EVALUATION OF GROUND-WATER CONDITIONS

LANDFILL L-4

TOWN OF NORTH HEMPSTEAD

February 1977

FIGURE 1

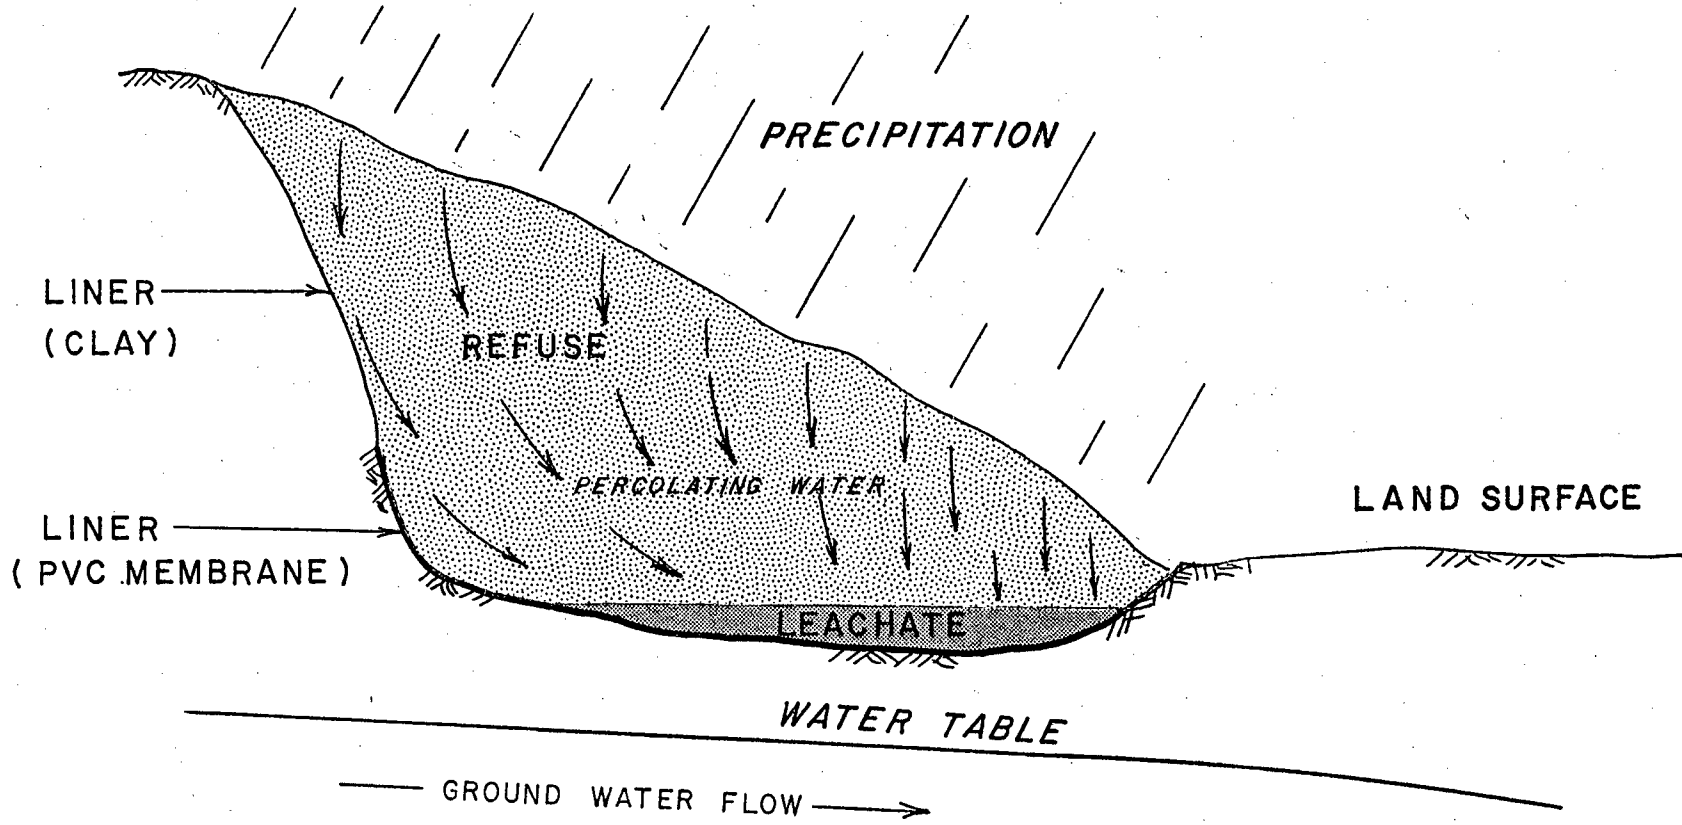
A statement on Page 7 asserts: "Leachate will drain directly to the soil through the banks. The seepage through the higher elevations along the banks to the south, west and north constitute (sic) a major threat to the water supply of the entire peninsula. Contaminated leachate entering at upwards of 100 feet and more (up to elevation 150 $\pm$  msl) above the normal groundwater elevation (20 $\pm$  msl) at the site will be capable of very lengthy lateral travel against and with the normal groundwater flow."

Water infiltrating the landfill will move as unsaturated flow only after the field capacity of the refuse has been reached. In other words, the refuse will absorb and retain water up to a point. Beyond that point, excess water moves downward under the influence of gravity, following the path of least resistance or highest permeability. Since the fill is probably more permeable than the bank surfaces, the percolating water

should move downward through the fill until it reaches a zone of saturation at a relatively low elevation - the surface of the leachate contained within the liner (Figure 1). Were it to reach the water table, its movement would then be to the east, the direction of shallow ground-water flow beneath the site. Seepage into the banks at higher elevations is simply not significant because of the unsaturated flow conditions. To state that the seepage (alleged) constitutes a threat to the water supply of the entire 10-square-mile peninsula is irresponsible and in no way based on scientific evidence or even accepted theory.

**FIGURE 2**  
GENERALIZED WEST-EAST CROSS SECTION  
SHOWING CONTAMINATED GROUND WATER  
TOWN OF NORTH HEMPSTEAD LANDFILL

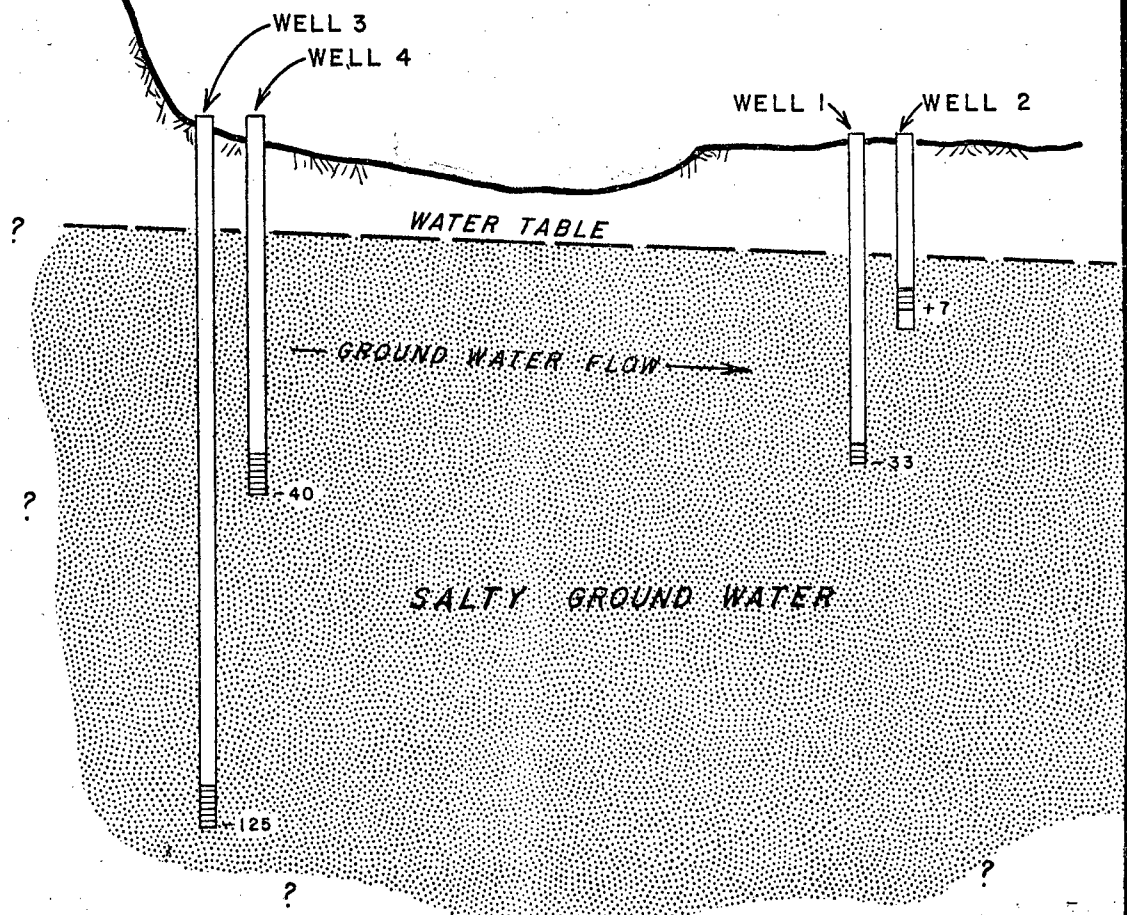
On Page 11 of the Henderson and Casey report, it is stated that "contamination of the landfill operations will eliminate future options for full groundwater exploitation along Hempstead Harbor." This is simply not the case because any ground water

that the leachate might reach is already contaminated with salt water (Figure 2). The monitoring wells were installed for the landfill and not to define the vertical and horizontal extent of existing salt-water contamination. However, Well 3 has its screen at a similar elevation to the one in the Southport Well, about 1,500 feet to the west (Figure 2). As noted in the preceding paragraph, the Port Washington Water District could have conducted pumping tests and used this well for observation purposes to determine rate and direction of ground-water flow. Apparently, this was not done.

DATE 7-14-76	HENDERSON & CASEY	EXH. 3
SCALE 1"=1 MI.	CONSULTING ENGINEERS

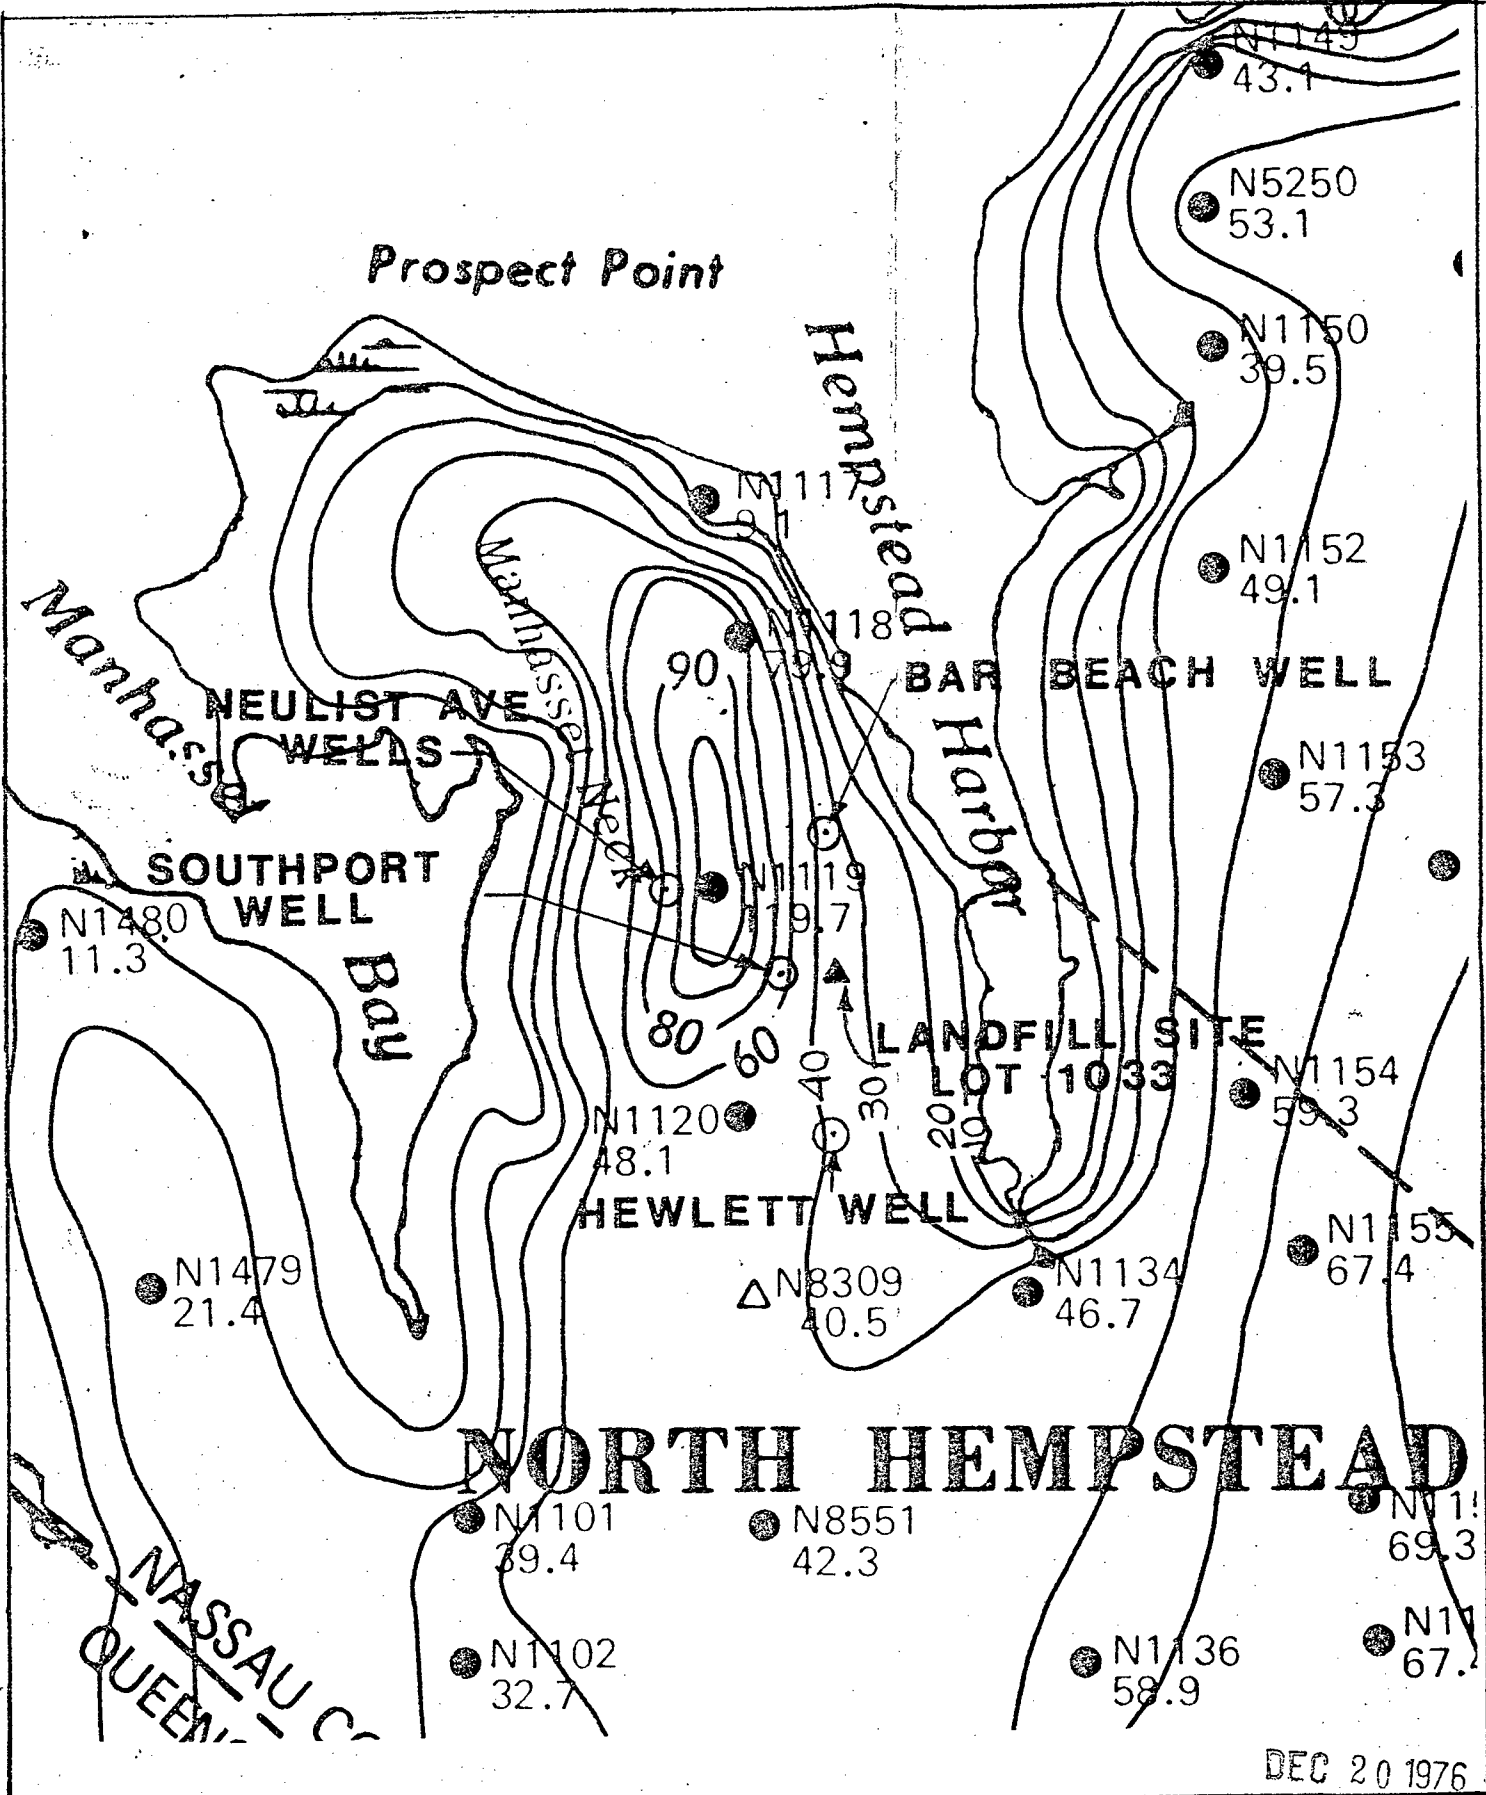
Shallow test borings installed at the landfill site in 1973 showed that the water table slopes toward Hempstead Harbor. The same is indicated by Exhibit 3 (copy attached), in the Henderson and Casey report, which is a contour map of the water table in 1974. Because ground water flows at right angles to the contour lines, the flow direction is clearly to the east. The only way the flow patterns could be affected is by pumping, and there are no wells in the vicinity of the landfill that pump significant quantities of water from the water table. Pumpage from greater depths could induce vertical leakage from the water table into underlying artesian zones, but there is no evidence that leakage is great enough to alter flow patterns in the water table. It is not envisioned that any changes will take place in the foreseeable future.

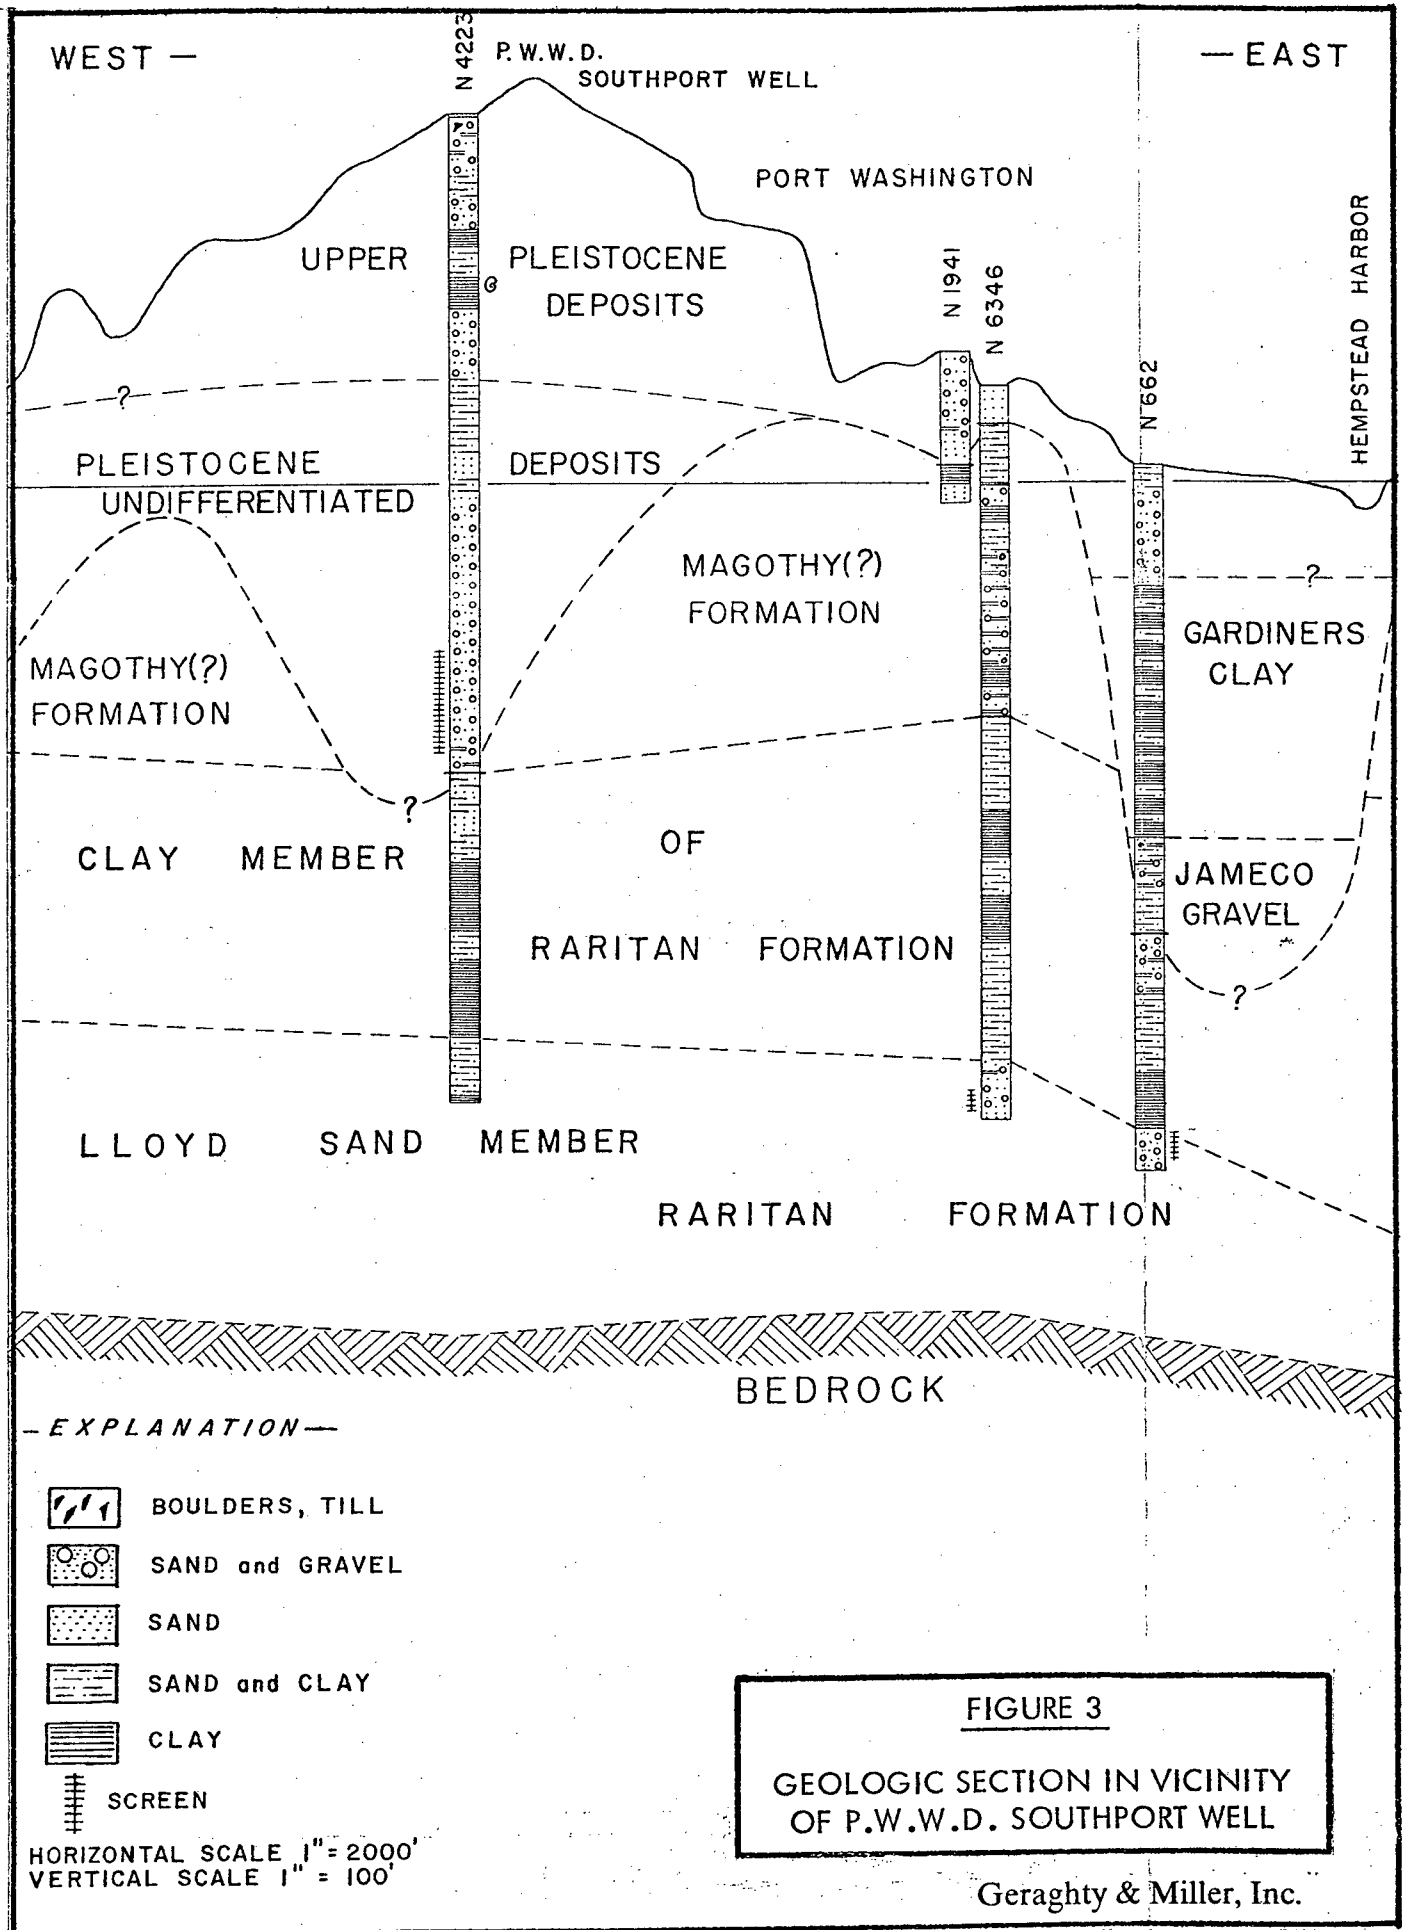
The geology in the sand pit is quite complex. As can be seen from Figure 3, the Southport Well (N 4223) is screened in what appears to be a north-south trending valley of more permeable deposits than are found to the east or west. Under such conditions, the pumping cone of depression created by the well would be elongated to the north and south and not extend a proportional distance to the east or west. This could account for the fact that chlorides in the well water have remained low even though salty water is less than 1,500 feet from the well.
